D/DRC Case

3326 Kline Street

DESIGN/DEVELOPMENT REVIEW COMMISSION
DESIGN REVIEW DISTRICT
HISTORIC AGENDA
EVALUATION SHEET
Case # 1

NATURE OF REQUEST: Request Certificate of Design Approval for exterior changes: replacement of original wood windows and replacement of original door

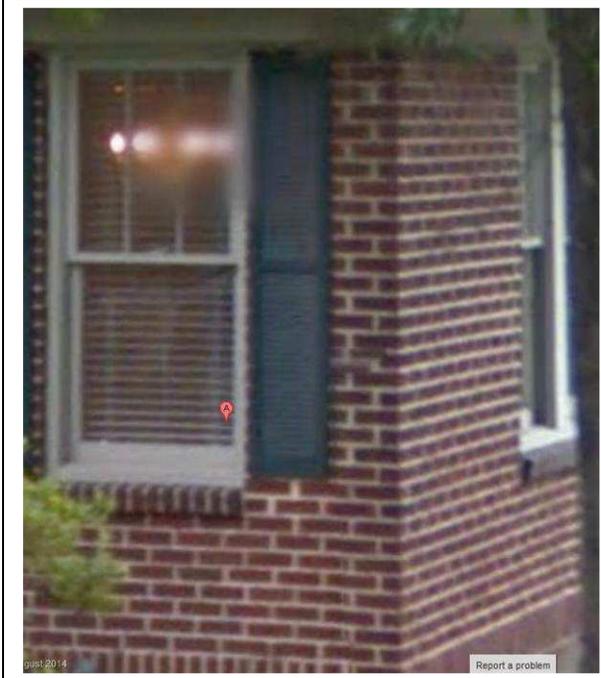
The vinyl windows that were installed do not match the material, glazing, reflective quality and detailing of the original windows. They feature integrated screens that obscure the windows somewhat from view, but they are clearly not the original wood windows. Their GBG detail allows for a solid sheet of glass in front of the false muntins, which creates a different reflective quality than is seen in true divided lite windows. The rails and stiles of the vinyl sashes are very uniform in size and therefore do not replicate wood window details. The vinyl window inserts also create more framing around the glass sashes than originally existed since they are built as an independent unit with their own jambs. Finally, the vinyl material does not replicate historic wood windows in material. Therefore, the proposed vinyl windows do not meet this guideline.

Staff was not able to evaluate if wholesale replacement was necessary but the proposed windows are not appropriate to the home's period of significance and do not maintain the use of historic materials. Therefore the proposed windows do not meet this guideline.

Staff further recommends that the vinyl windows be removed within 60 days and that they be replaced with windows in keeping with Section 7 of the guidelines: true-divided lite, wood, double-hung sash windows with single-pane glass of a 3/1 configuration matching the details of the wood windows that were removed from this home.

Above and Left: August 2014 Google images

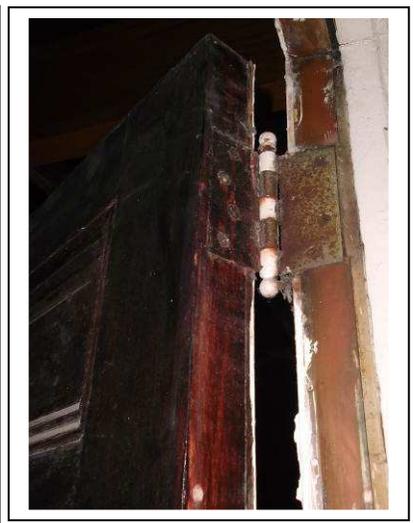
Staff was unable to look at the original windows in person but the images from the Google streetview appear to show intact 3/1 windows. There are no violation notices on file from the City indicating that they had found the building or its windows to be in disrepair.
